Project	<b>IEEE 802.16 Broadband Wireless Access Working Group</b> < <a href="http://ieee802.org/16">http://ieee802.org/16</a> >	
Title	<b>Comments on MS Initial Ranging with Non-transparent RS (Centralized)</b>	
Date Submitted	<b>2007-07-16</b>	
Source(s)	<p>Kanchei (Ken) Loa, Yi-Hsueh Tsai, Yung-Ting Lee, Hua-Chiang Yin, Shiann-Tsong Sheu, Youn-Tai Lee,</p> <p>Institute for Information Industry 8F, No. 218, Sec. 2, Dunhua S. Rd., Taipei City 106, Taiwan</p> <p>Masato Okuda</p> <p>Fujitsu</p>	<p>Voice: +886-2-27399616 Fax: +886-2-23782328 <a href="mailto:loa@nmi.iii.org.tw">loa@nmi.iii.org.tw</a></p> <p><a href="mailto:okuda@jp.fujitsu.com">okuda@jp.fujitsu.com</a></p>
Re:	IEEE 802.16j-07/019: "Call for Technical Comments Regarding IEEE Project 802.16j"	
Abstract	This contribution proposes modifications for MS Initial Ranging with Non-transparent RS	
Purpose	Text proposal for 802.16j Baseline Document.

# Comments on MS Initial Ranging with Non-transparent RS (Centralized)

Figure 95e Handle CDMA Initial Ranging Code at Non-transparent RS

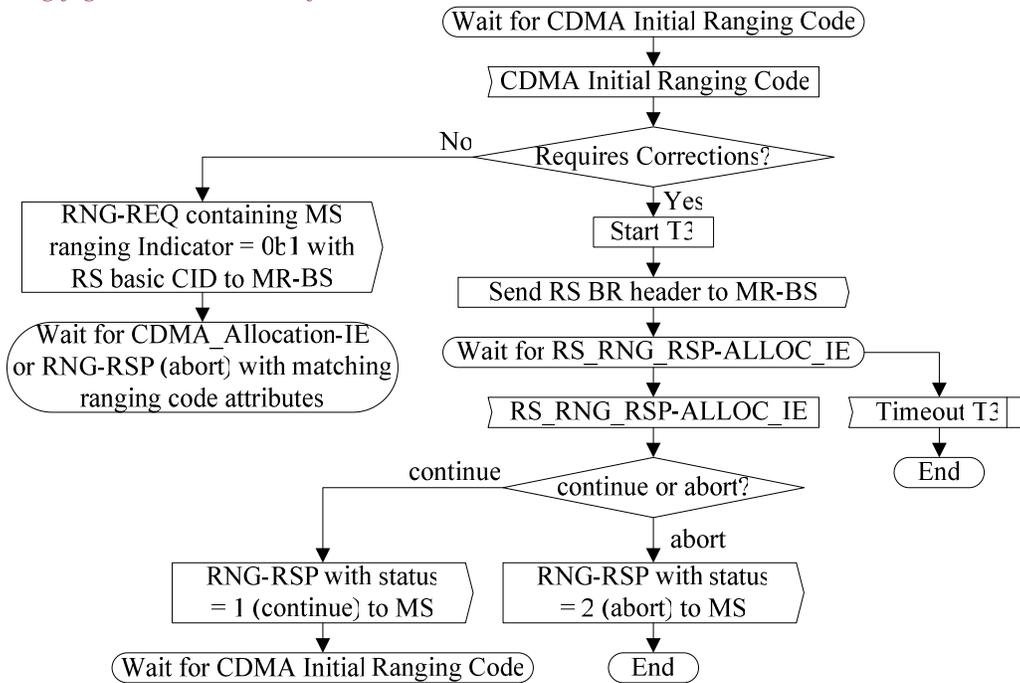
[Insert the following figures at the end of subclause 6.3.9.16.2.1:]
